**PLANNED UNIT DEVELOPMENT****Date: April 5, 2018****DEVELOPMENT NAME**

Robert Myers

**LOCATION**2955 and 2989 Dauphin Street  
(Southeast corner of Dauphin Street and Sage Avenue)**CITY COUNCIL****DISTRICT**

Planned Unit Development Approval to allow shared

# SITE PLAN

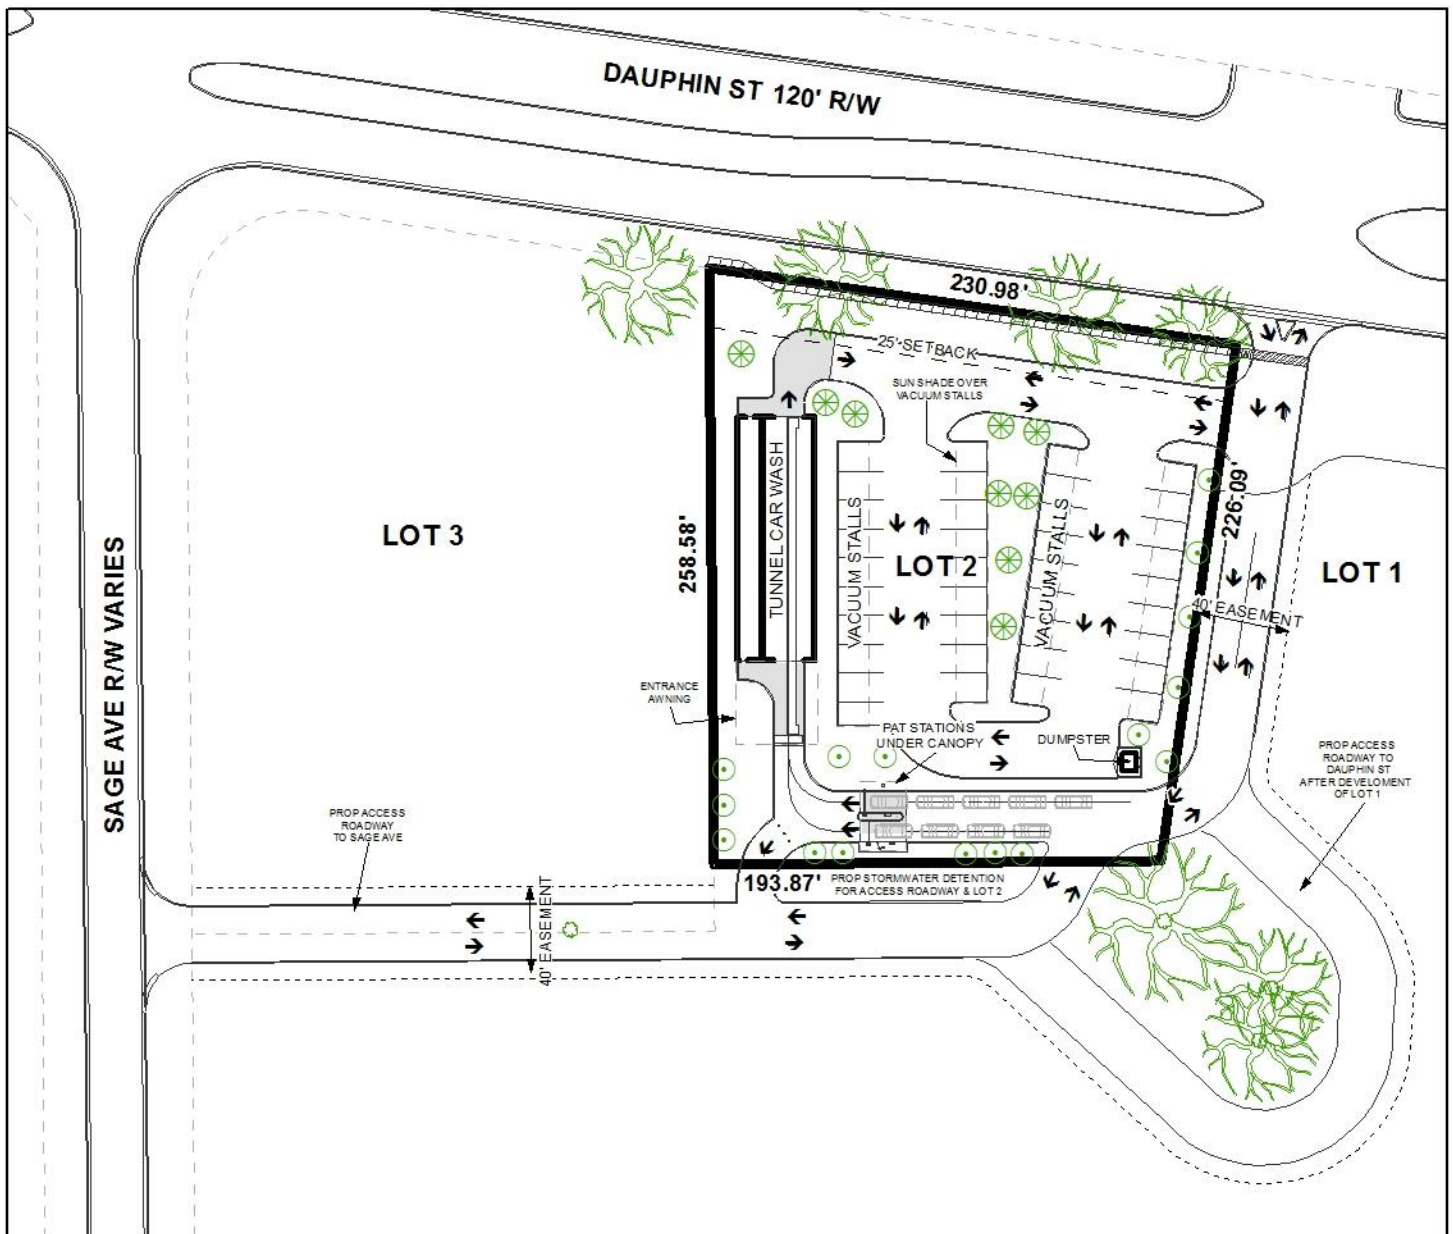
The lot fronts Dauphin Street, a major street according to the Major Street Plan component of the Comprehensive Plan, with a 120' right-of-way, which exceeds the 100 feet requirements, therefore no dedication will be required. The lot also has access to Sage Avenue via an access easement across two other lots that will be constructed and used to connect to Dauphin Street. The site plan depicts the right-of-way width along Sage Avenue as varying, however, information on the Final Plat, recorded in 2008, shows the right-of-way as 60' for Sage Avenue. The site plan should be revised to depict the accurate right-of-way width along this portion of Sage Avenue.

The 25' minimum building setback line is depicted on the site plan for the lot being developed and should be retained on any future plans.

As a means of access management, the lot proposed for development should be limited to the curb-cuts as previously approved, that is, the lot will have a direct curb-cut to Dauphin Street, but will utilize one shared curb-cut to Dauphin and one curb-cut to Sage.

All proposed parking areas for the site appear to be compliant in terms of travel aisle width, parking stall dimensions, and number of spaces; however, it should be pointed out that the site plan does not depict any accessible parking spaces/ vacuum stalls, therefore the site may not be in compliance with building code requirements and the Americans with Disabilities Act. The site plan should be revised to depict compliant accessible parking, which may include the provision of one accessible parking space and one accessible vacuum stall.

A sidewalk is shown along the frontage of the site as well as proposed dumpster location. The illustrations should be retained on any revised PUD site plan, along with a note acknowledging compliance with Section 64-4.D.9. of the Zoning Ordinance regarding dumpster compliance.

The site plan provides landscaping information and illustrates tree plantings, however the required amount of frontage trees for the site appear to be short. After allocations for the canopy overhang have been taken in account for the existing live oaks within the right-of-way, the site is still short 1 frontage tree. Adequate tree planting and landscaping for the remainder of the site is provided. A revised site plan depicting one additional frontage tree will be required. All revisions must comply with Section 64-4.E. of the Zoning Ordinance regarding tree and landscaping requirements.

In regards to the proposed car wash, full carwash compliance of the Zoning Ordinance is required. As such, all water run-off must be directed to the sanitary sewer system, an oil separator must be provided, and vehicles must be screened from view with at 3'-5' evergreen hedge and/or landscaped berm.

Lighting is not illustrated on the site plan. Any new lighting on the site will have to comply with the requirements of Sections 64-4.A.2., 64-6.A.3.c., and 64-6.A.8. of the Zoning Ordinance. A note reflecting this requirement should appear on the site plan, and photometric plans will be required at the time of submittal for land disturbance.

It should be pointed out that there was no signage information provided for the proposed site. If approved, the proposed development on Lot 2 will be limited to one freestanding sign and two wall signs.
